# Product Change Notification

Overview: Please be advised that the following is notice of change to the following Fire Research 10 ft. sensor cables described below.

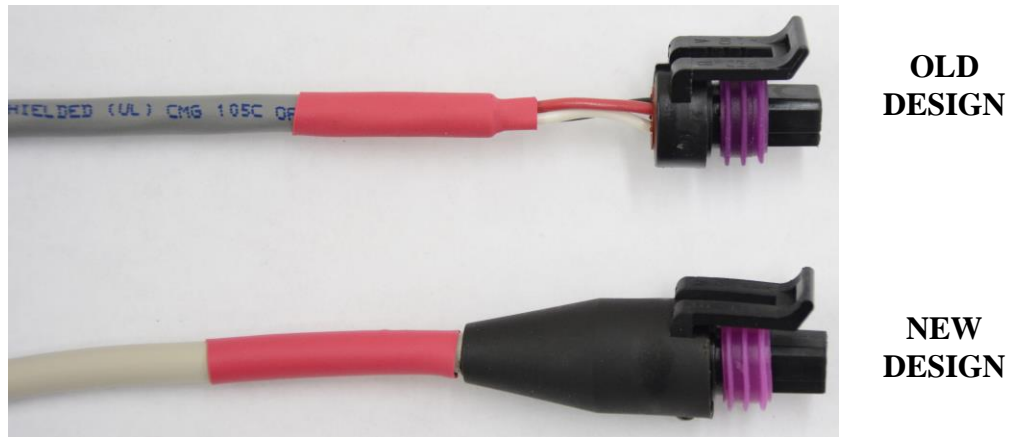
Change Description: Effective immediately, FRC has changed the connector style and cable for the 10 ft. sensor cable assemblies. The new connector is equipped with a cover that extends onto the wire sleeve. The new cable will have a white sleeve; the previous cable had a grey sleeve. The wire gauge, length and other parameters remain the same. This is the same form, fit and function as before.

Reason for Change: This change was implemented to better protect and act as a water seal. This redesign also helps to maintain the wiring integrity by preventing overly straining the wiring from tension, or pulling between the wiring and the connector.
